# UNITED STATES PATENT AND TRADEMARK OFFICE

APPLICATION NO.	FILING DATE	FIRST NAMED INVENTOR	ATTORNEY DOCKET NO.	CONFIRMATION NO.
10/799,307	03/12/2004	Jae-Hyun Kim	8054-50 (LW9007US/HJ)	8101
22150 7590 05/02/2008 F. CHAU & ASSOCIATES, LLC 130 WOODBURY ROAD WOODBURY, NY 11797				
EXAMINER				
CHEN, LUCY P				
ART UNIT		PAPER NUMBER		
2871				
MAIL DATE		DELIVERY MODE		
05/02/2008		PAPER

### Office Action Summary

## DETAILED ACTION

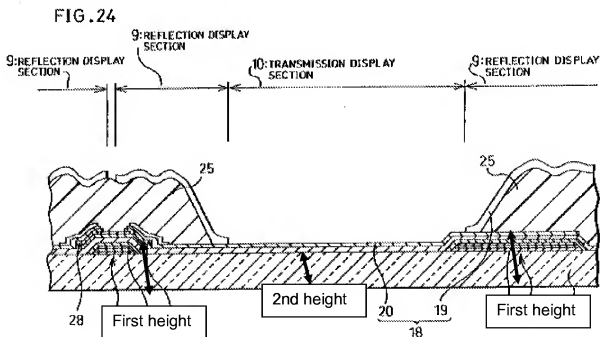
Baek et al discloses (Page 3, [0037]) the color filter layer in the transmitting portion is twice as large as the thickness of the color filter in the reflective portion to improve the color purity of the light passing through the color filter in the transmissive region. (Page 2, [0014], [0015]) therefore the pixel electrode has a first height (d3) at the reflecting area and a second height (d4)at the transmitting area wherein the first height is greater than the second height with respect to the substrate.
